Well Name: JAMES RANCH UNIT APACHE	Well Location: T22S / R30E / SEC 24 / NESE / 32.37646 / -103.828736	County or Parish/State: EDDY / NM
Well Number: 136H	Type of Well: OIL WELL	Allottee or Tribe Name:
Lease Number: NMNM89051	Unit or CA Name:	Unit or CA Number:
US Well Number: 3001556021	Operator: XTO PERMIAN OPERATING LLC

Notice of Intent

Type of Submission: Notice of Intent	Type of Action: APD Change
Date Sundry Submitted: 03/04/2025	Time Sundry Submitted: 08:18
Date proposed operation will begin: 03/07/2025

Procedure Description: XTO Permian Operating, LLC. respectfully requests approval to make changes to the drilling program in the approved APD & requests permission for a primary and a contingency drilling program for this well. Primary will be a 4-string design with an engineered weak point (R-111-Q: Figure F) & the contingency will be a 3-string design with an open production casing annulus (R-111-Q: Figure B). See attached drilling program for the primary & contingency design with updated casing design, cement program & mud circulation system. No changes to the SHL, KOP, FTP, LTP, BHL, proposed depth, pool & dedicated acreage. There will be no new surface disturbance.

[Figure F] 4 String – 2nd Intermediate casing engineered weak point

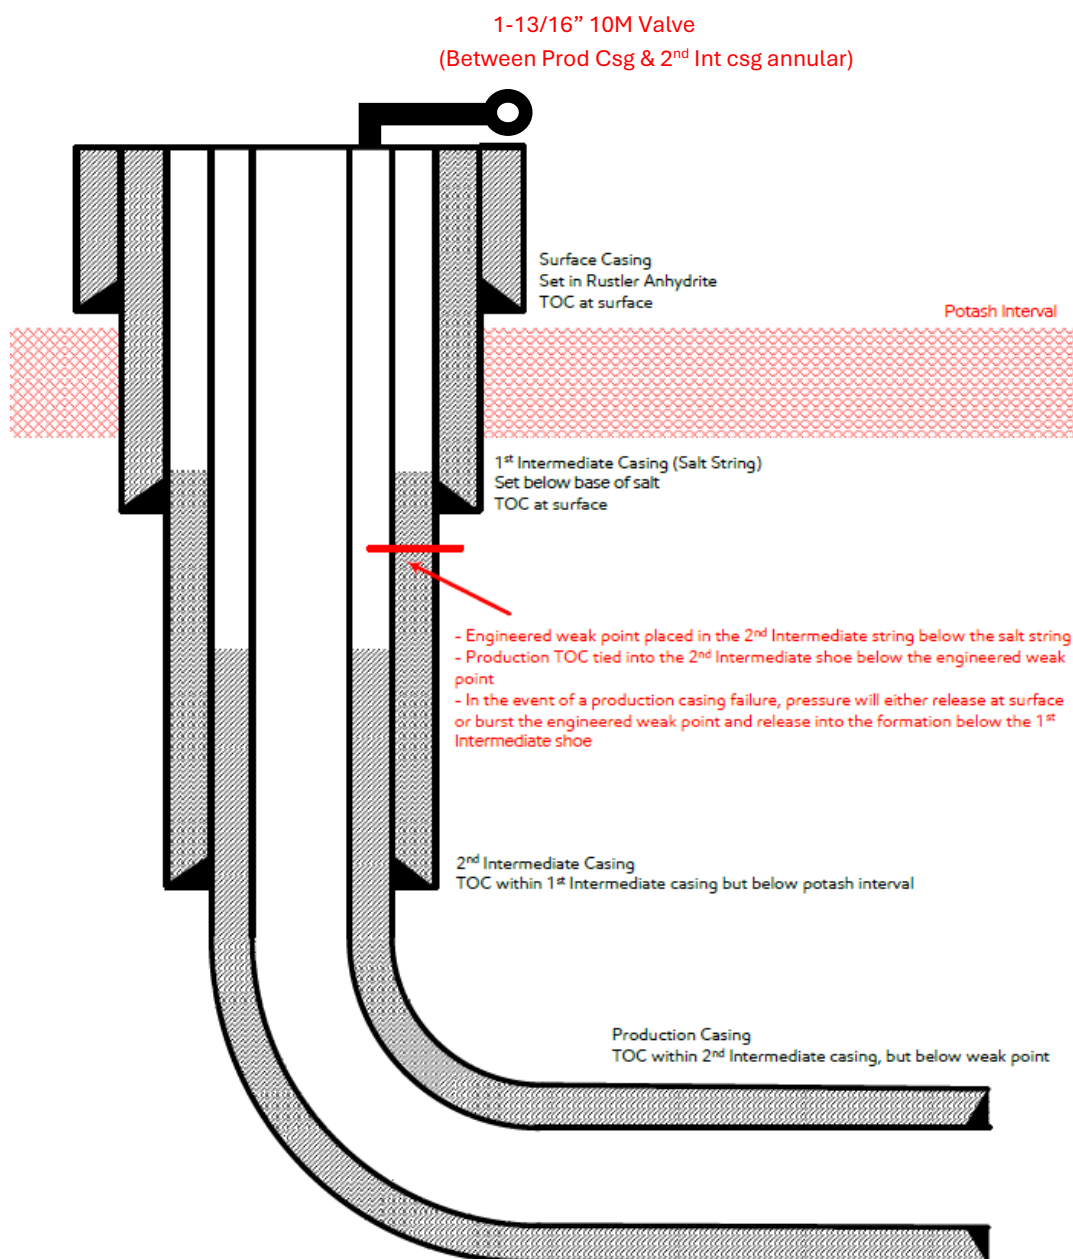
Update May 2024:

XTO is aware of R-111-Q update and will comply with these requirements including (but not limited to):

- 1) Alignment with KPLA requirements per schematic below, with engineering weak point casing design and utilizing new casing that meets API standards.
- 2) Contingency plans in place to divert fluids away from salt interval in event of production casing failure.
- 3) Intermediate 2 casing will consist of a primary cement job with TOC at the top of the Brushy Canyon formation within the Delaware Mountain Group.
 - a. Bradenhead squeeze to be completed after primary cement job to tie back TOC to intermediate 1 "Salt string" & below Marker Bed 126 "Potash Interval".
- 4) Production cement to be tied back no less than 500' inside previous casing shoe (intermediate 2 casing) and below the engineered weak point.

Figure B – 3 String Design – Open Production Casing Annulus (Updated May 2024):

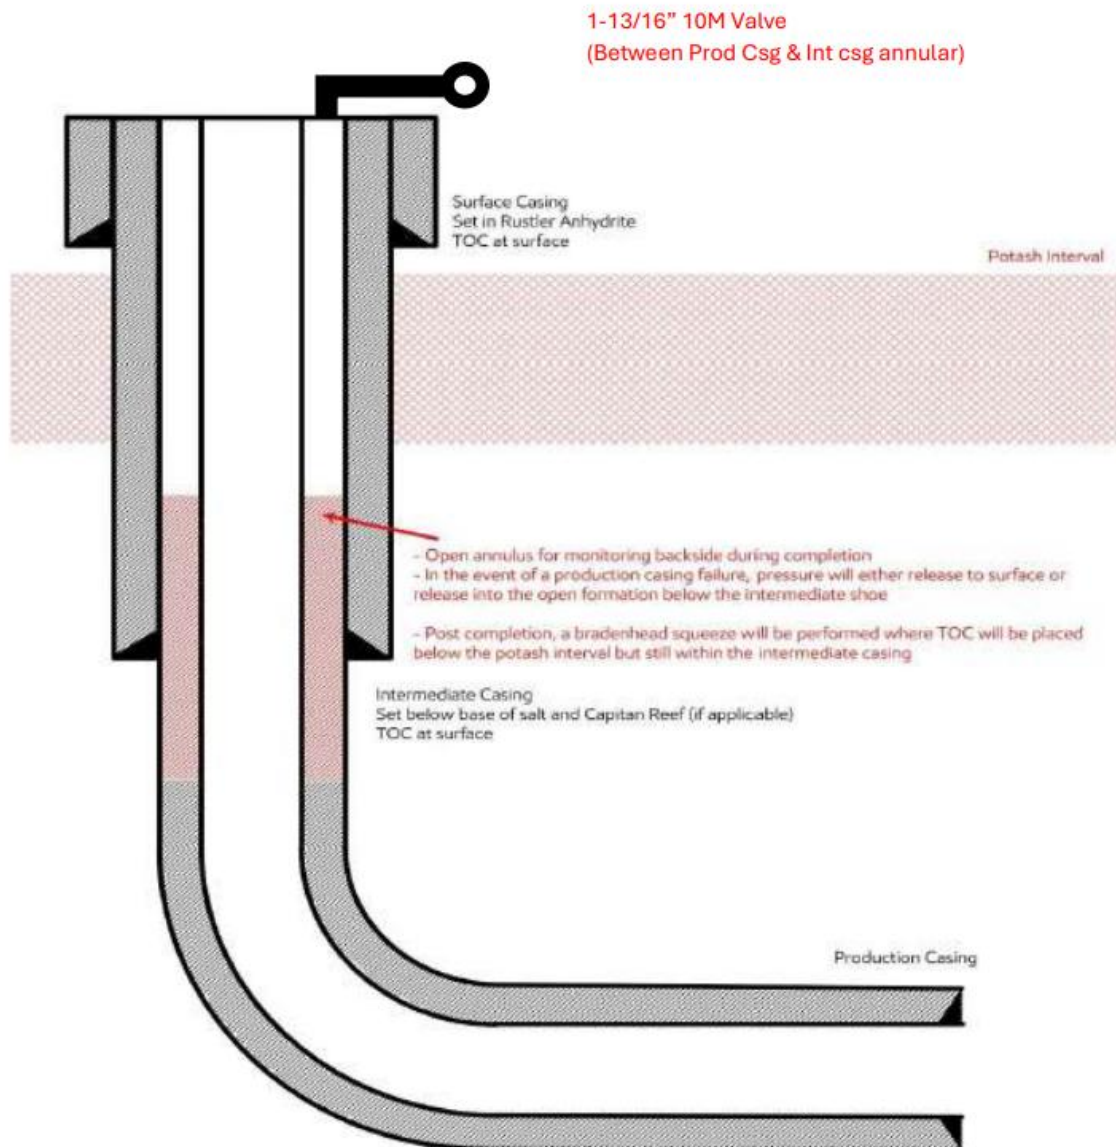
XTO is aware of the R-111-Q update & will comply with these requirements including (but not limited to):

1. Alignment with KPLA requirements per schematic above, leaving open annulus for pressure monitoring during frac and utilizing new casing that meets API standards
2. Contingency plans in place to divert formation fluids away from salt interval in event of production casing failure
3. TOC in the annulus between intermediate & production casing string shall stand uncemented at least 500 feet below the intermediate casing shoe
4. Bradenhead squeeze to be completed within 180 days after hydraulic frac operations have been concluded to ensure at least a 500 feet tie-back has been established inside salt string but with top below MB 126

OPEATOR IS APPROVED TO USE A 3 STRING DESIGN CASING PLAN. ALL R-111Q REQUIRIEMENTS ARE APPLY.
